## STAFF REPORT

STAFF  
REPORT: D'Aumeries Private Helipad BCUP (PLN 23-117)

**STANDARDS AND CRITERIA REVIEW**  
**PLN 23-117 / DAUMERIES / PRIVATE HELIPAD BCUP / 3700 TERRY ROBINSON**

# PROPOSED SITE PLAN

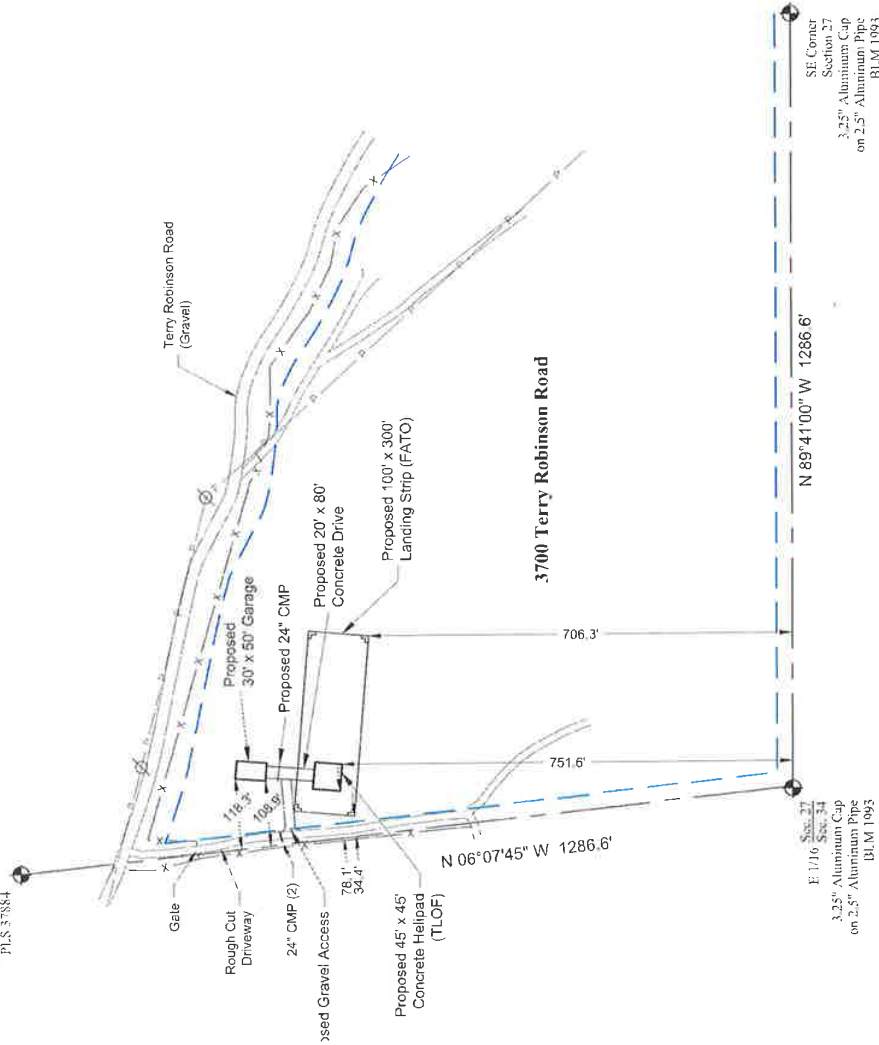
1. Applicant must ensure stormwater containment is maintained throughout construction.
2. Applicant must provide a Wetlands Development Permit from US Army Corps of Engineers prior to commencement of any development.
3. Applicant must limit site construction activities to the months of May through November to reduce impacts on wintering elk populations.
4. Applicant must submit updated Title Work and Site Plan identifying all easements of record and proper setbacks for development on the parcel.
5. Applicant must include location of the ditch and stream present on the parcel on the updated Site Plan to ensure no negative impacts from planned development.

<b>19</b>	<b>5.3.6</b>	<b>Utility Location</b>	LPEA Comments	MEETS	
<b>20</b>	<b>5.3.7</b>	<b>Sewage Facilities</b>		MEETS	
<b>21</b>	<b>5.3.8</b>	<b>Water Supply</b>	Applicant must include location of Echo Ditch on the Site Plan to ensure no negative impacts to the ditch from planned development.	NOT	5
<b>22</b>	<b>5.3.9</b>	<b>Fire Protection</b>	Applicant must provide adequate fire protection equipment (extinguisher) as required by NFPA 10 at the site.	NOT	6
	<b>5.4.1</b>	<b>Commercial Design Site Development Standards</b>
